PROJECT: TTU TRACK AND FIELD
SBC# 364/011-05-2025
BAA Project Number 25007
Cookeville, Putnam County, Tennessee

SUBJECT: Addendum No 1

DOOR SCHEDULE

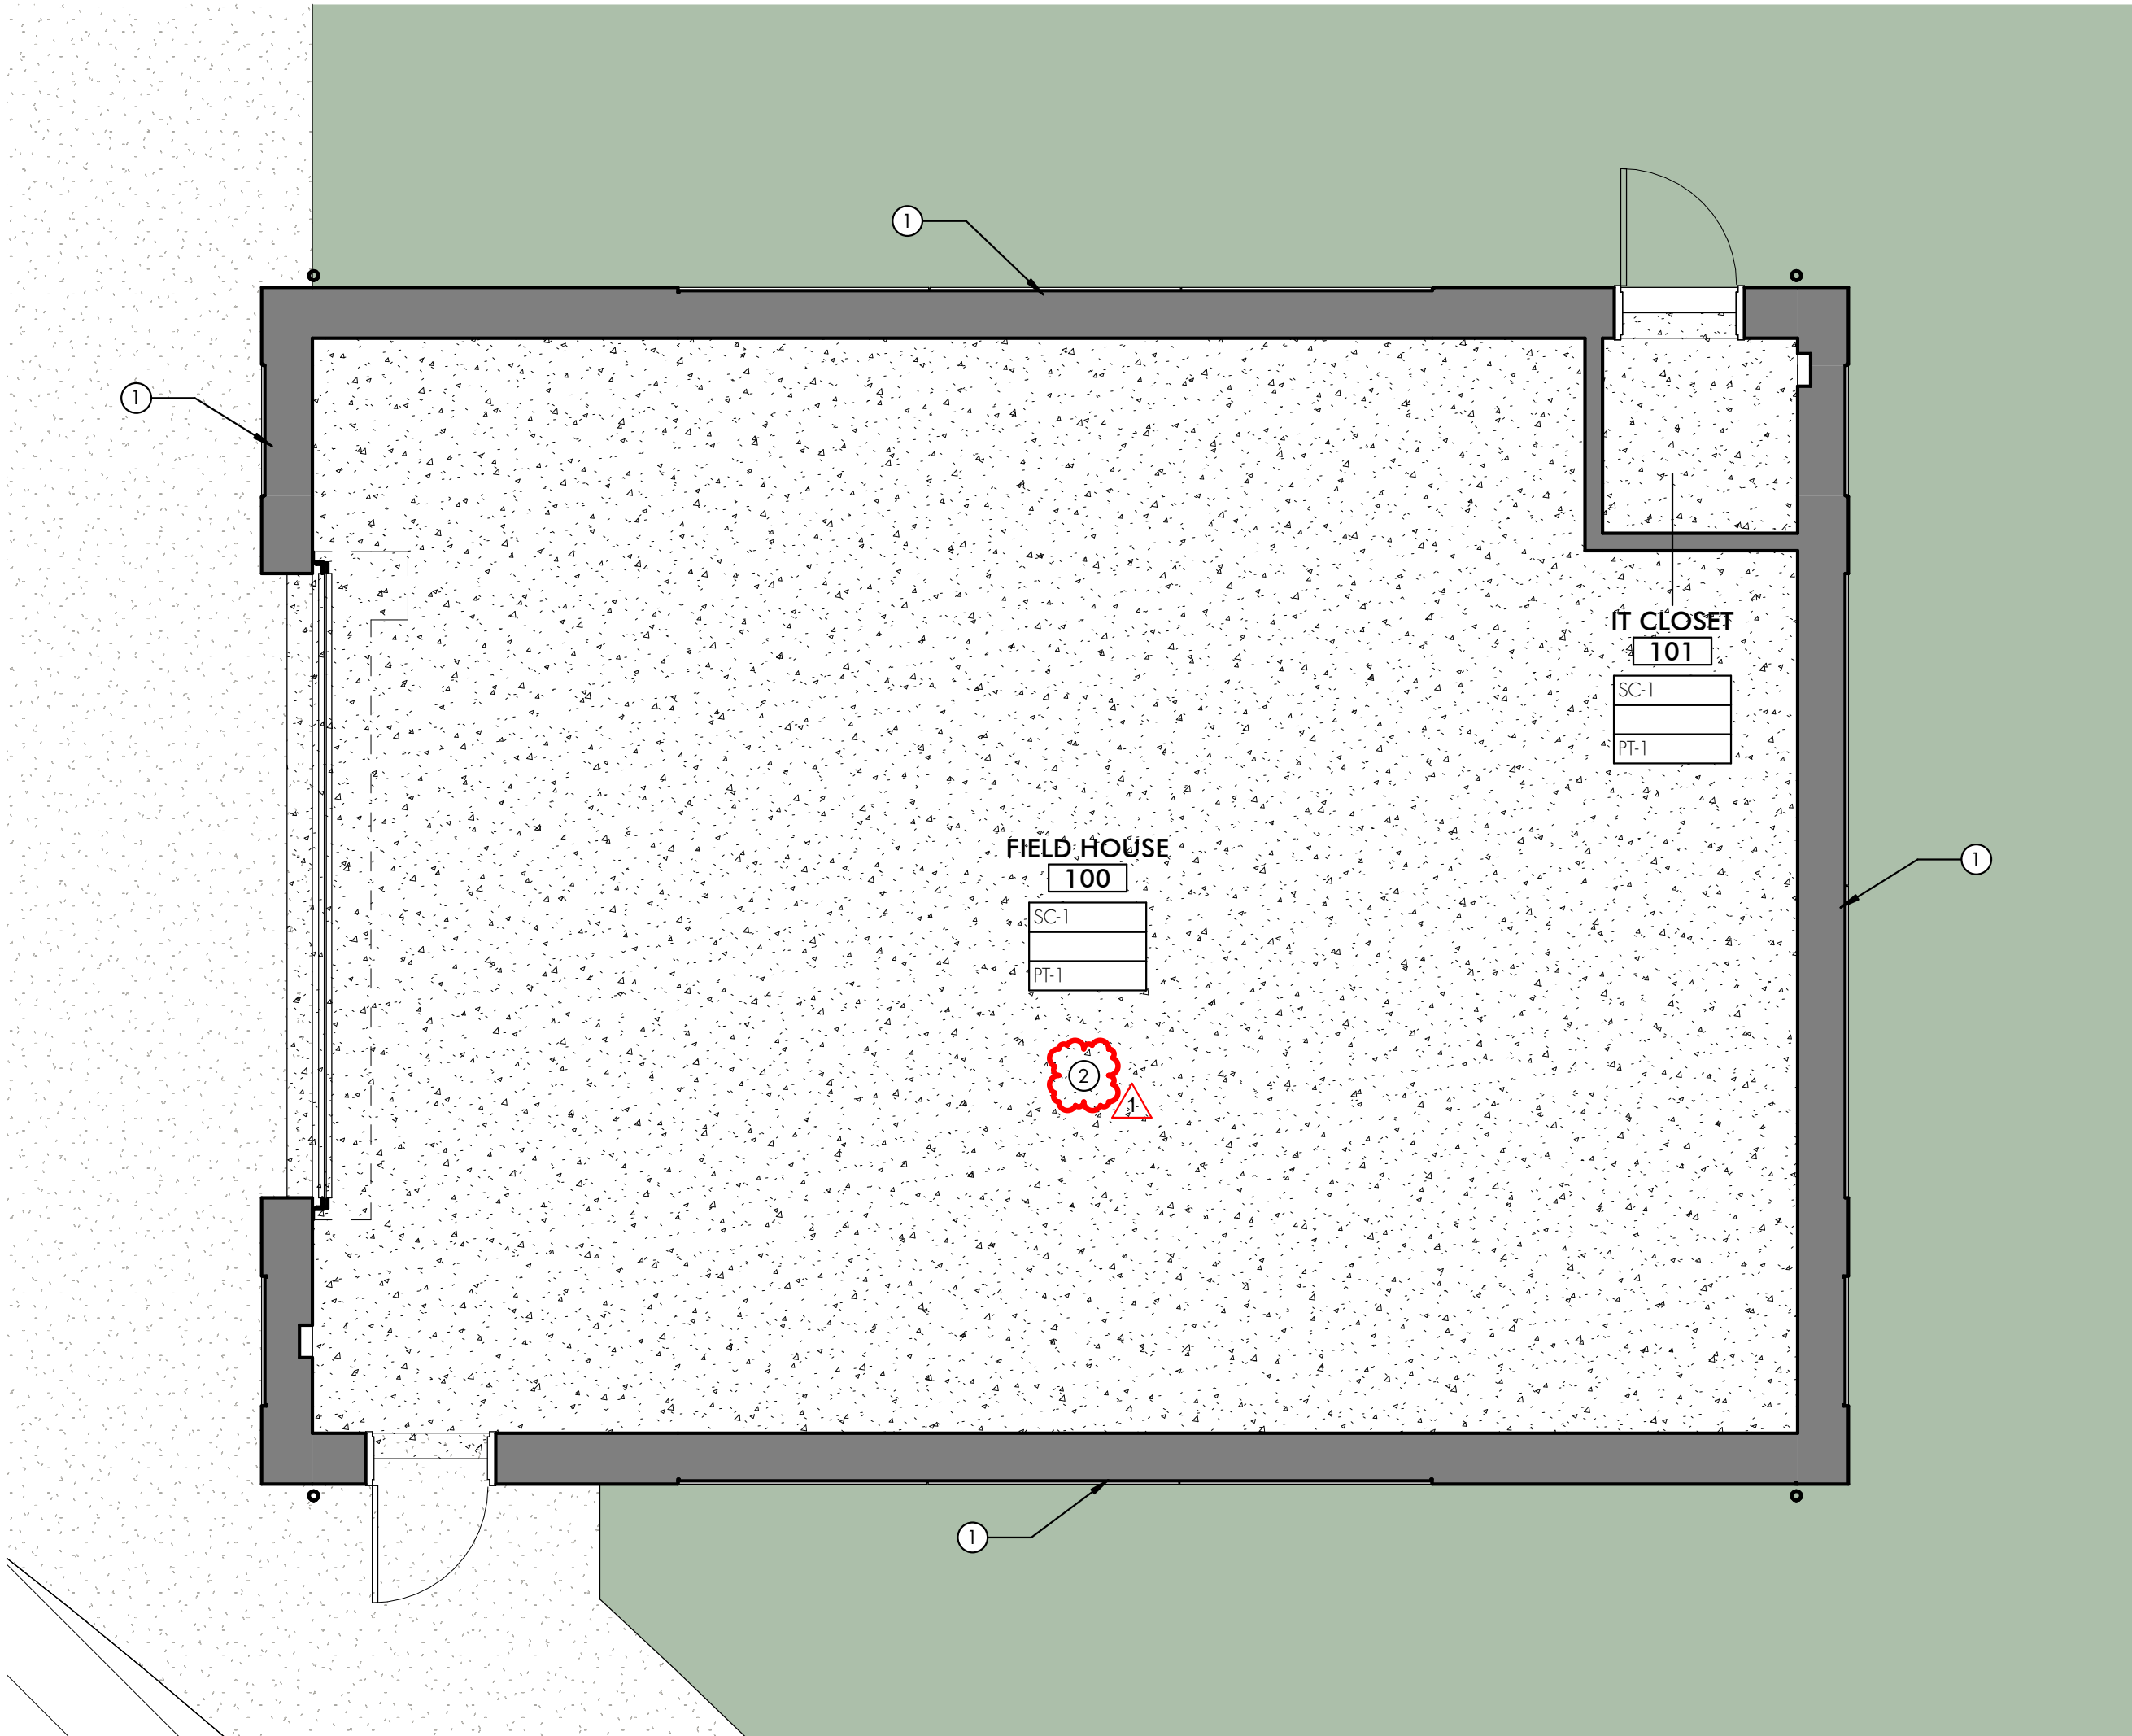
55. Question: Doors 101 and 102 have incorrect heights on the door schedule. What are the required heights?
Answer: Door 101 was revised to 8'-4" and Door 102 was revised to 10'-0" high on the door schedule. Refer to A6.01 in Addendum No. 1.

01 HVAC - FLOOR PLAN
1/4" = 1'-0"

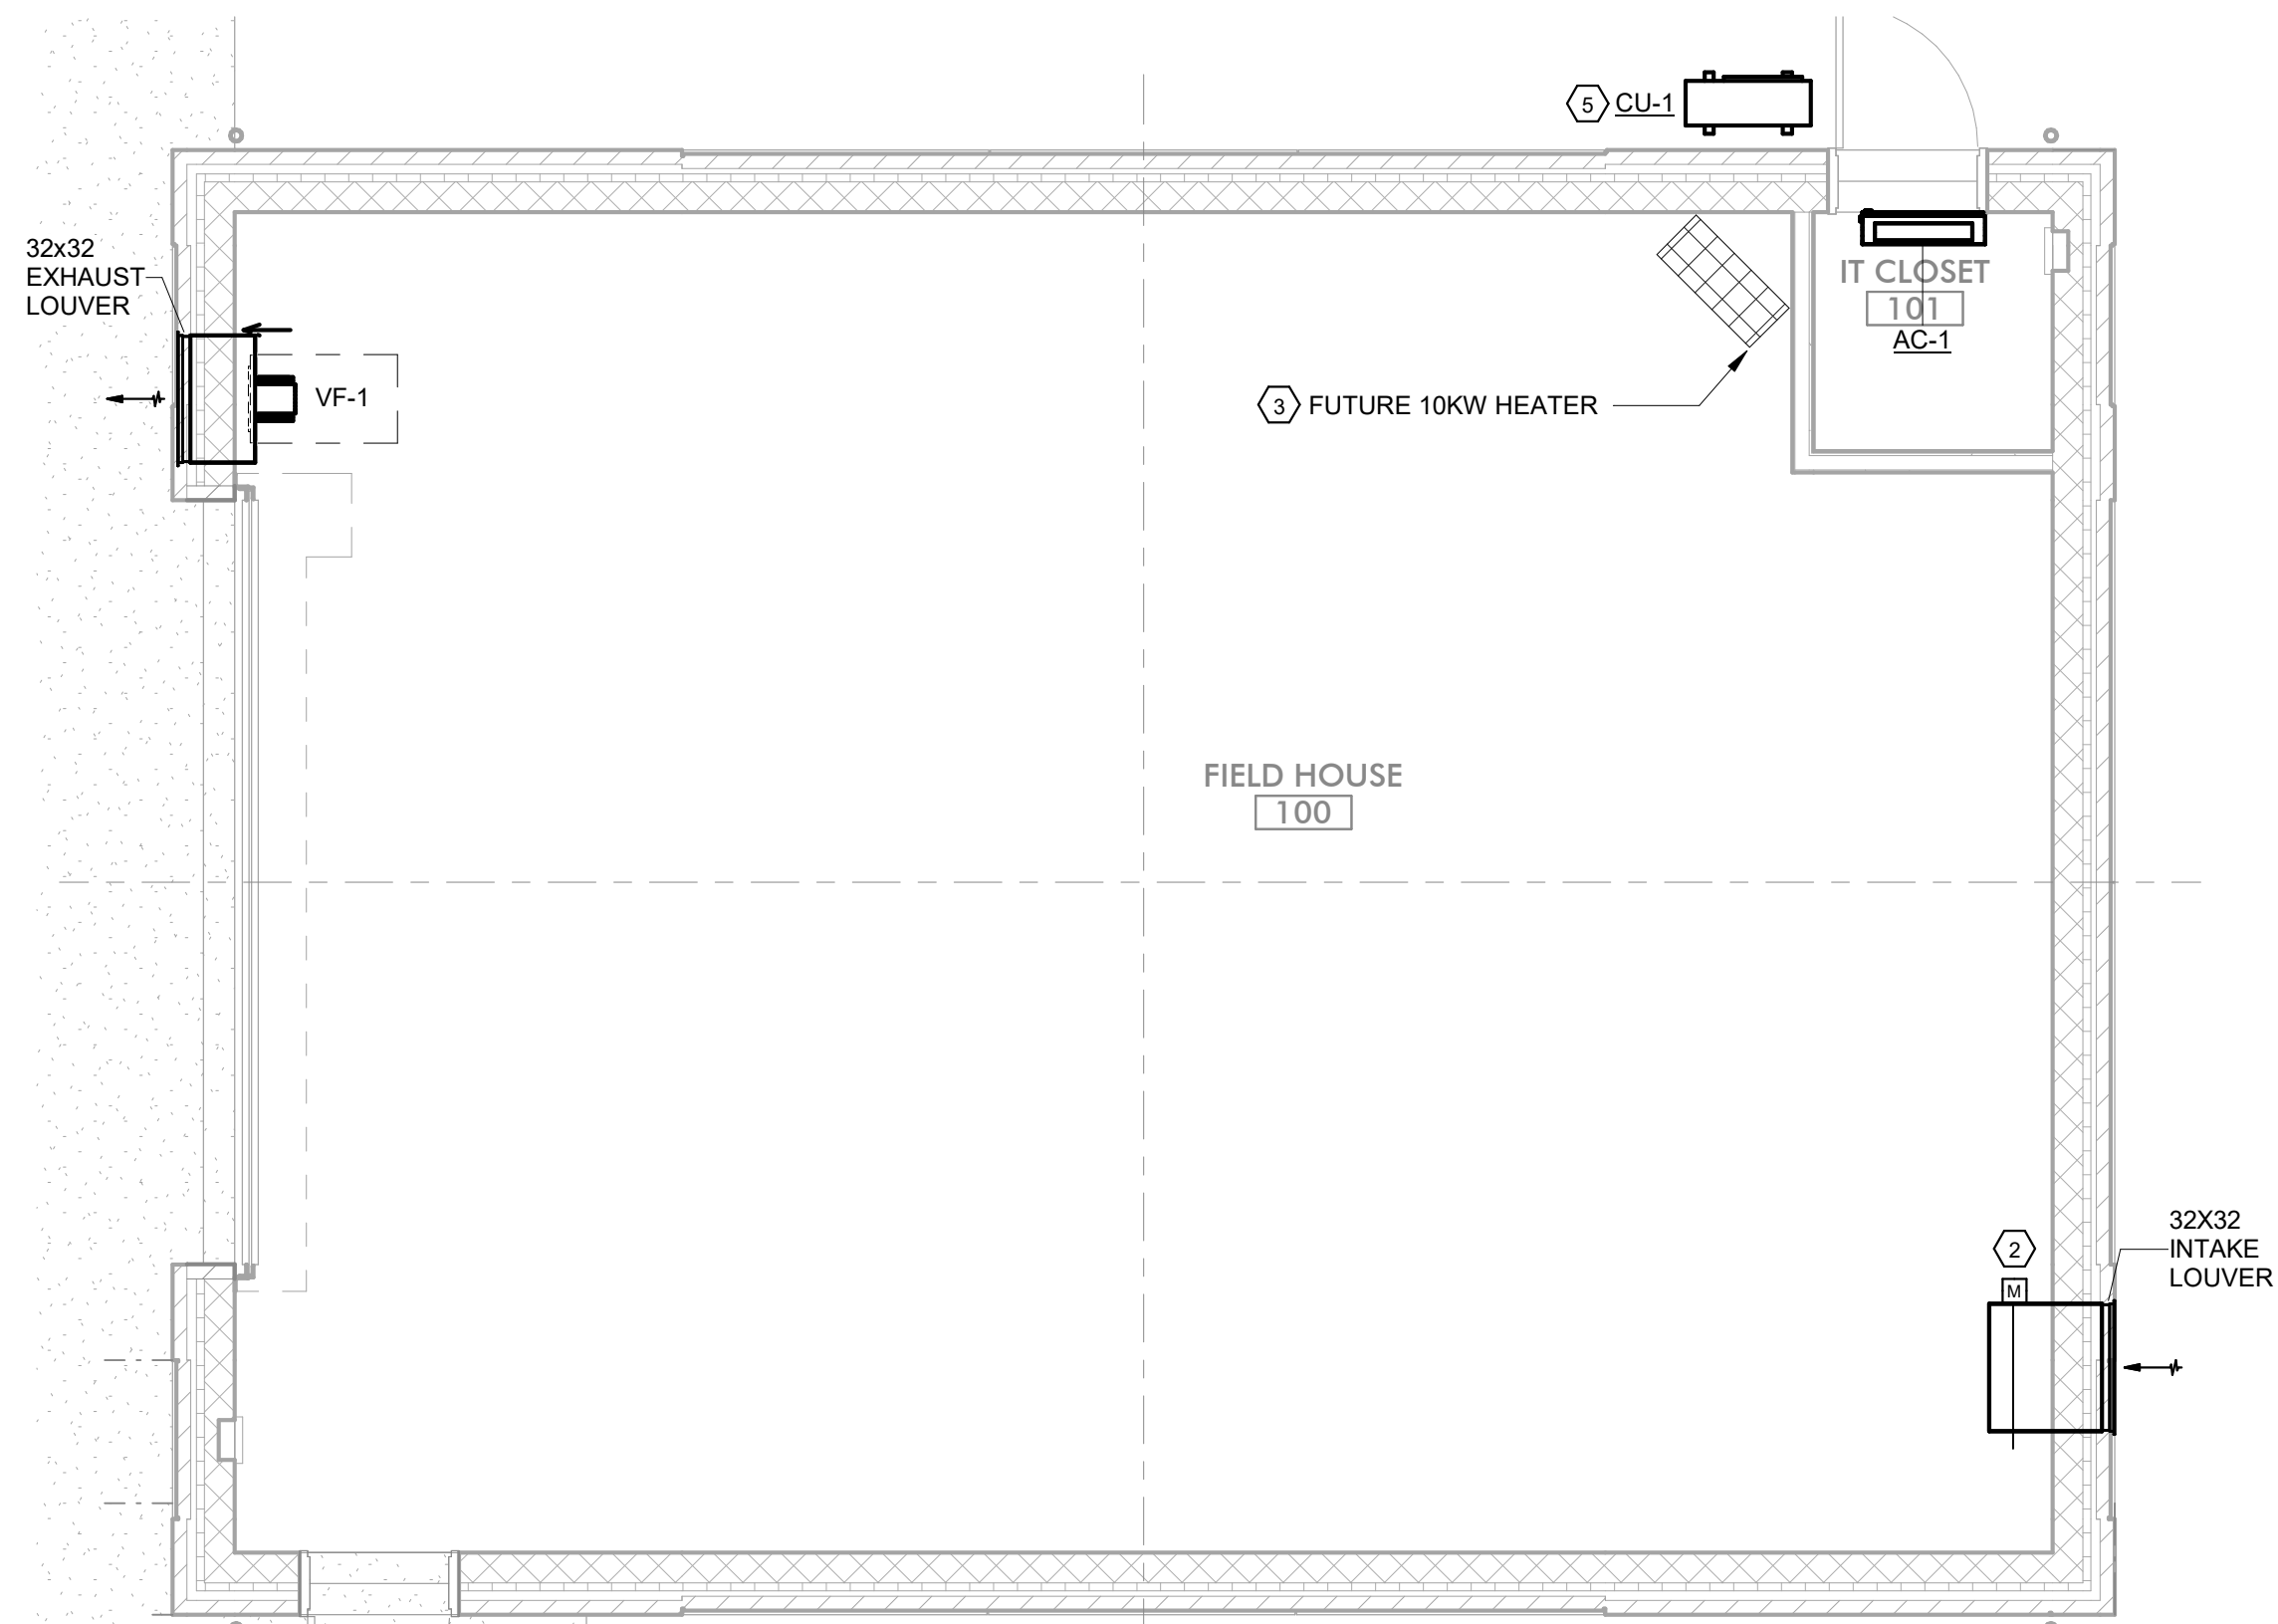
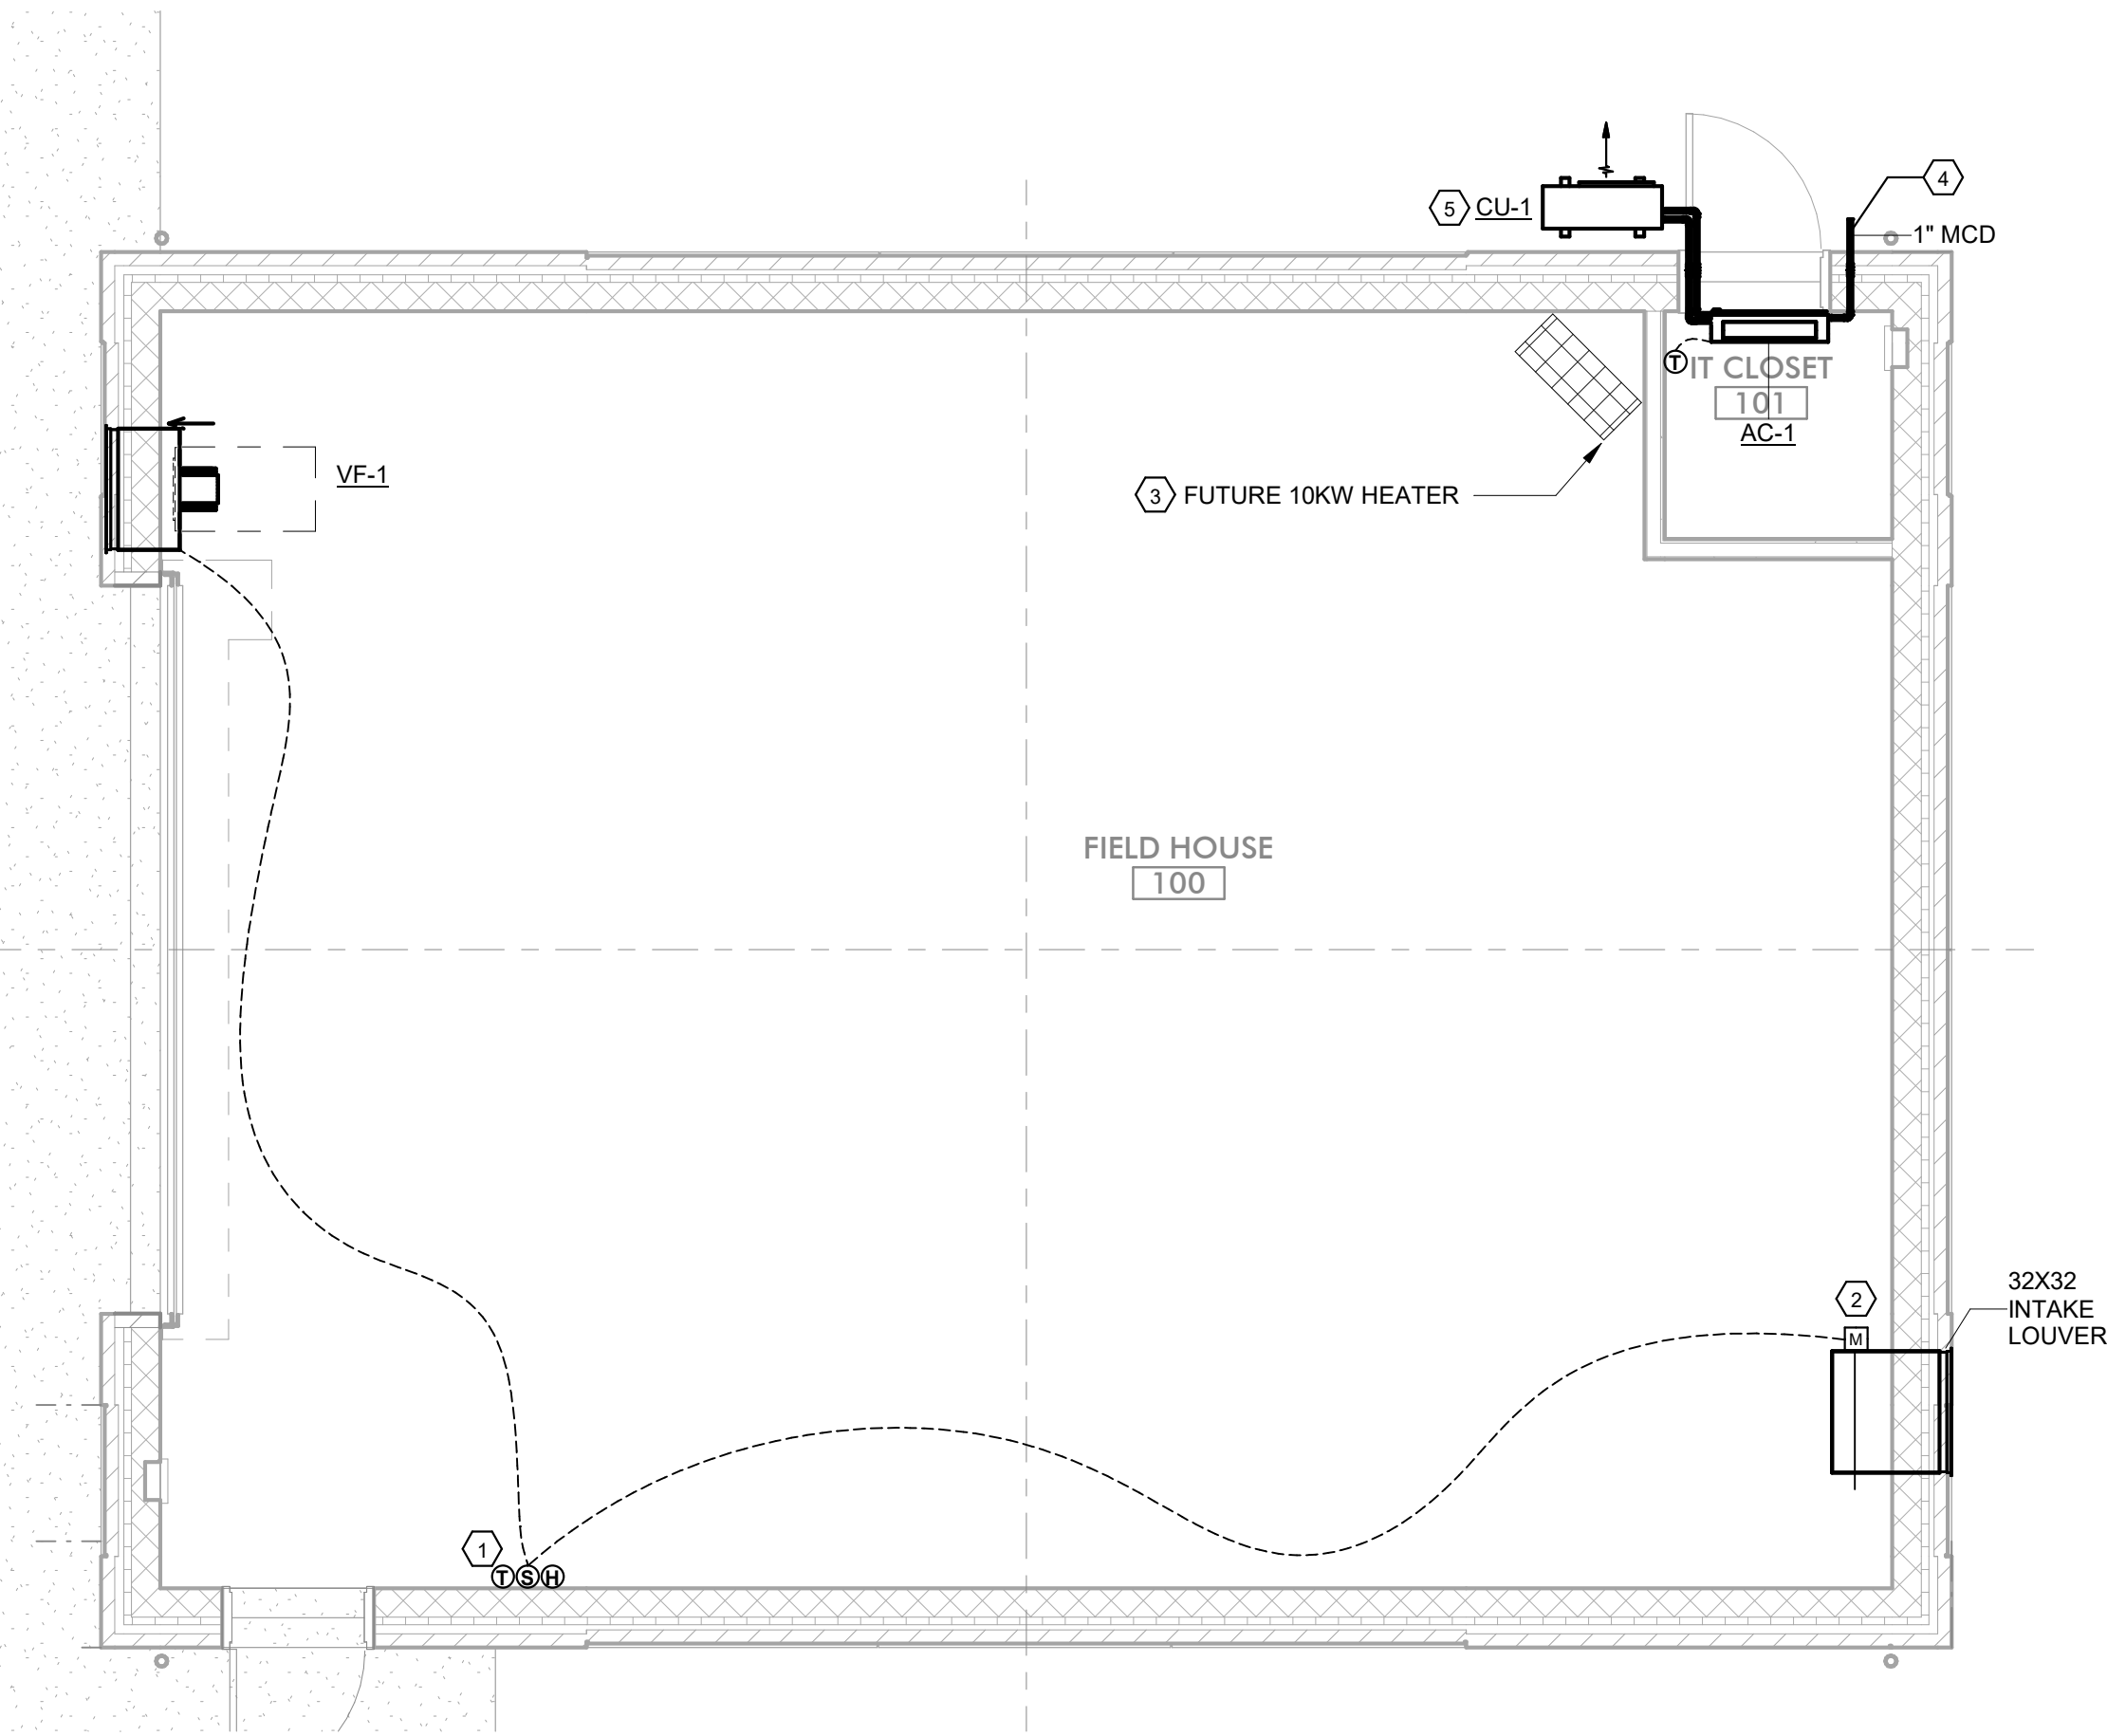
50. Question: No scale or dimensions were provided on M1.10. Has this been corrected?
Answer: The scale was updated as part of Addendum No. 1.
